Re: 10 Boston Street, Middleton, MA
40B Comprehensive Permit Application
Civil Engineering and Traffic Engineering Peer Review #1

Re: 10 Boston Street, Middleton, MA
40B Comprehensive Permit Application
Response to Civil Engineering and Traffic Engineering Peer Review #1

Re: Response to Traffic Engineering Peer Review #1
Proposed Residential Development – 10 Boston Street (Route 62)
Middleton, Massachusetts

LEFT-TURN LANE WARRANTS ANALYSIS

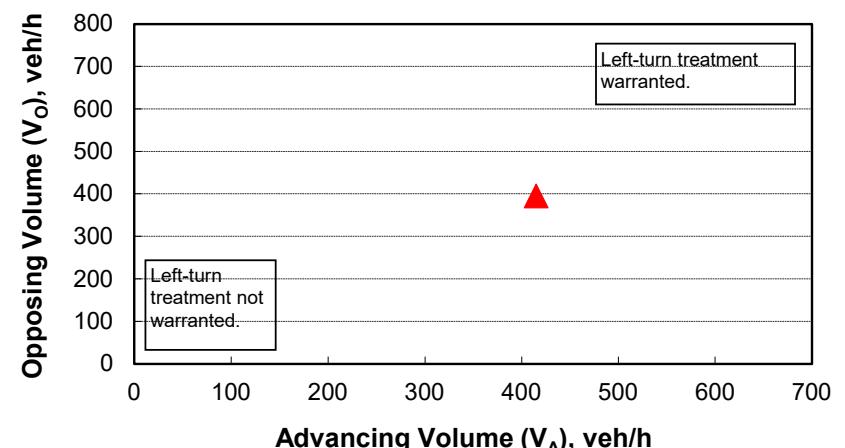
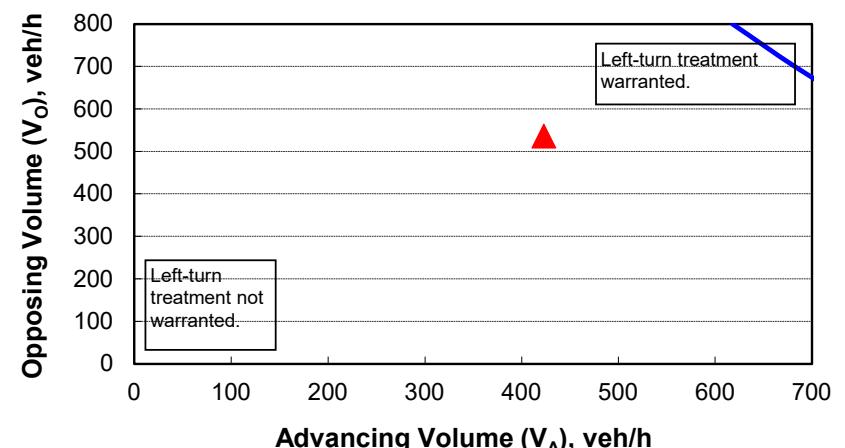
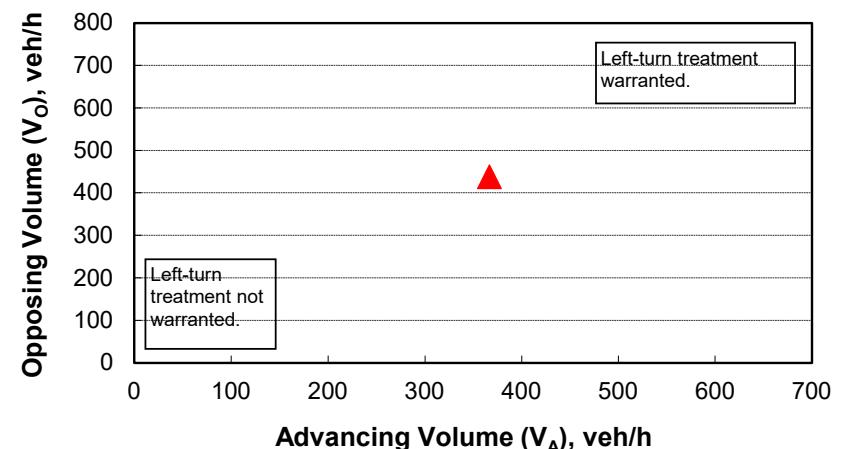
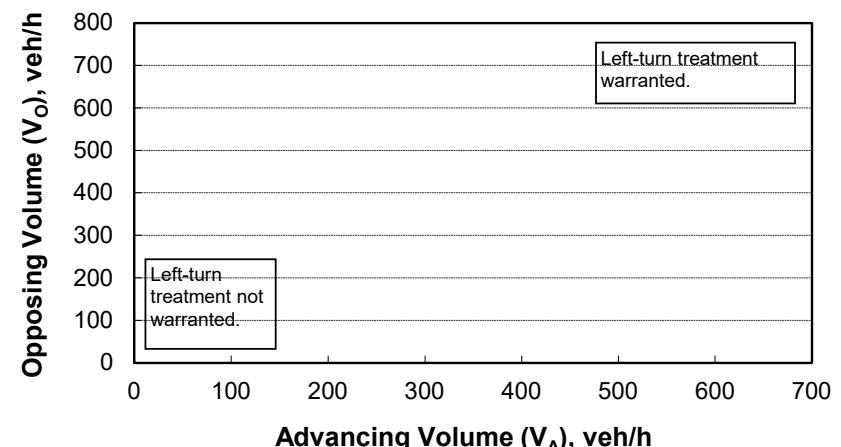
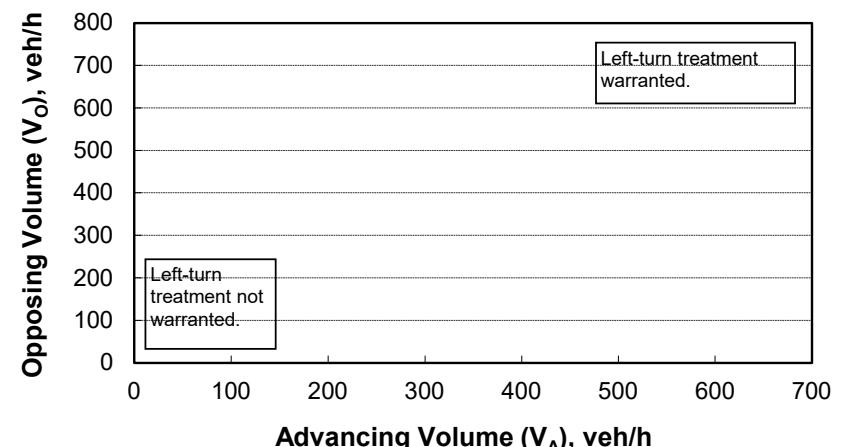
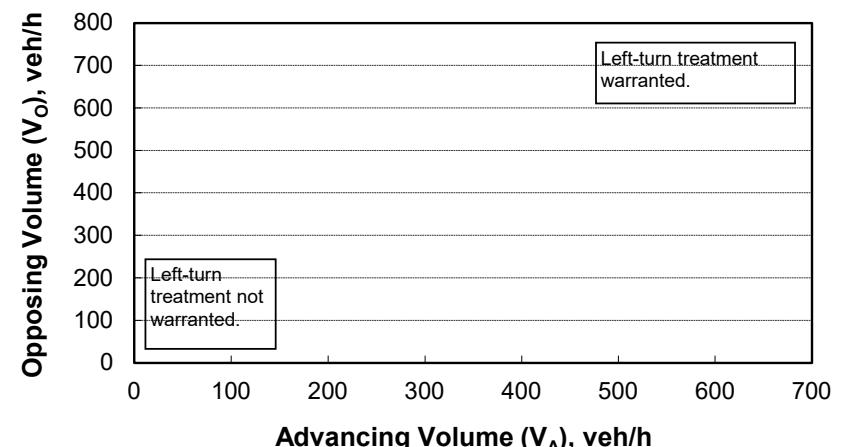
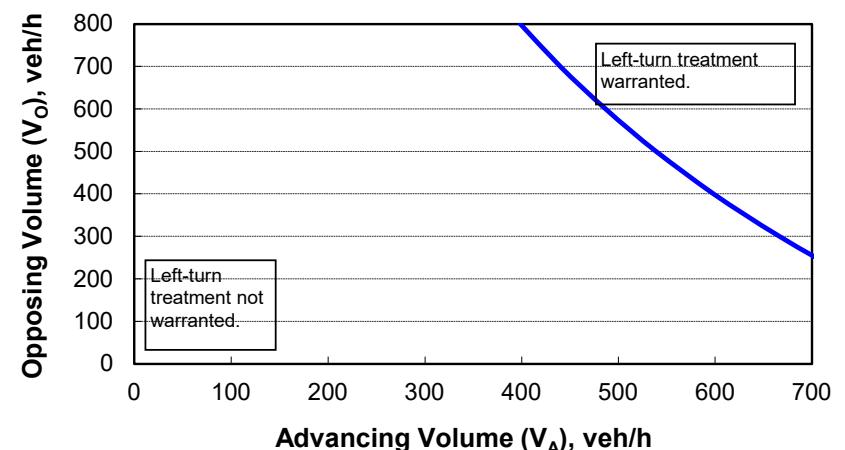
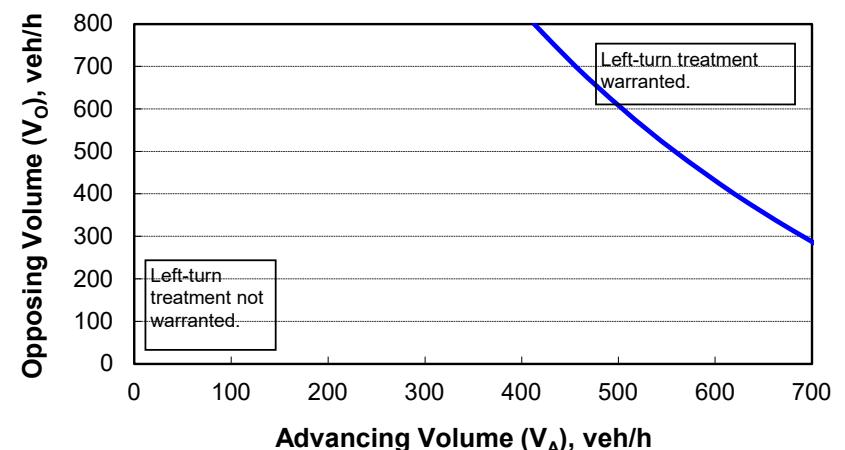
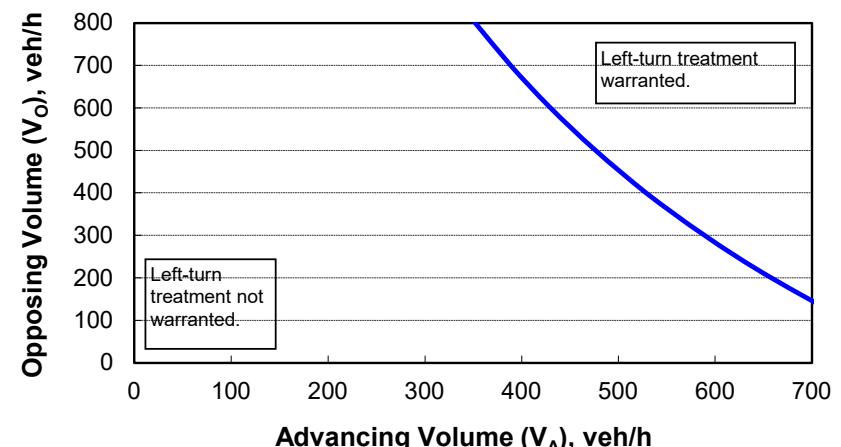
52. Similarly, the project projects a significant number of left turns into the South Main Street Driveway from the south. The Applicant should provide a left-turn warrant analysis for this location with and without the full build-out of Lot 3.
